Access Compliance Report Public Rights-of-Way (Curb Ramps)

Main Street: CROWN_VALLEY_PKWY		Cross Street: SIENNA_PKWY		Location:	S
ADA ID: RPRK211101115954	Ramp Type:Type 1 - Perpendicular Diagonal Initial Pass/Fail: Fail		Overall Compliance: No	Severity Score:	15
Codes/Mitigation Info/Possible Solution			Field Measurements/Component Compliance

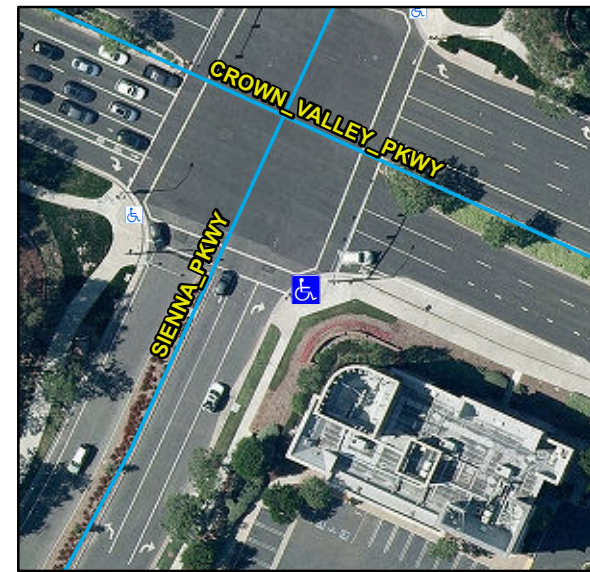
R304.2.2, R204.3, R304.5.3, STD 1115

Remove & Replace Curb Ramp With Two New Directional Ramps or Equivalent.
